MIL-M-28787/140B
AMENDMENT 1
31 March 1993

MODULES, STANDARD ELECTRONIC

MULTIPLEXER, DIGITAL, KEY CODE AGD

FIGURE 22. Power supply filter capacitance test circuit for table XX.

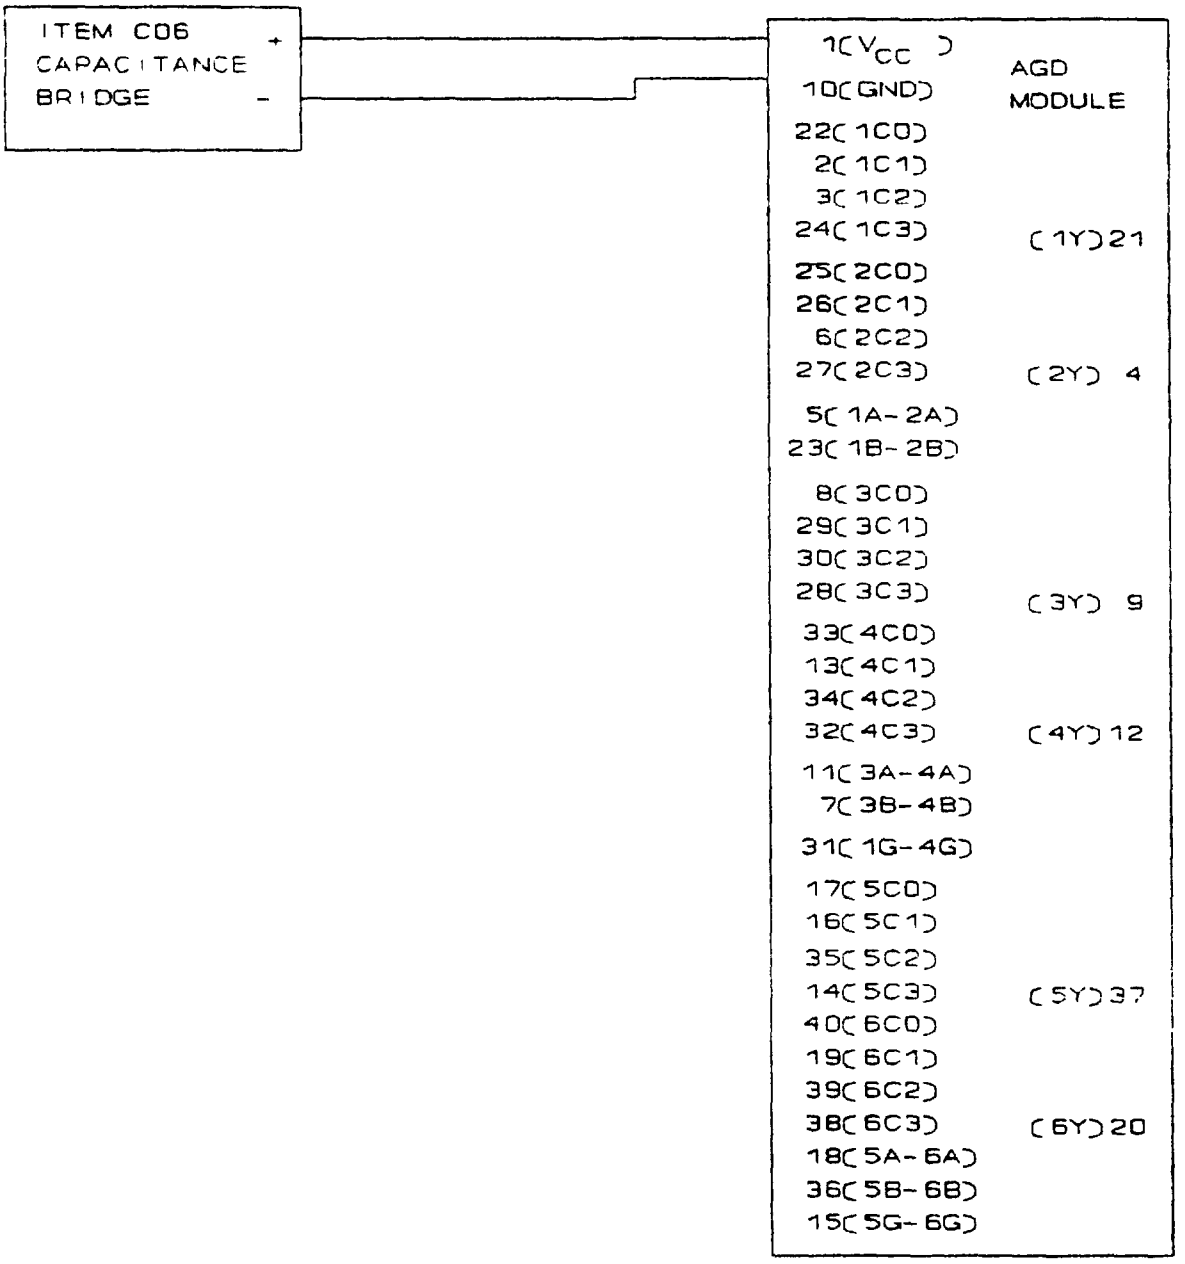
FIGURE 22: Delete and substitute new figure 22 as printed on page 3 of this amendment.

**NOTE:** Capacitance bridge (C06) setup: Frequency = 1kHz
$V_{pk}$ = 0.3 V maximum.
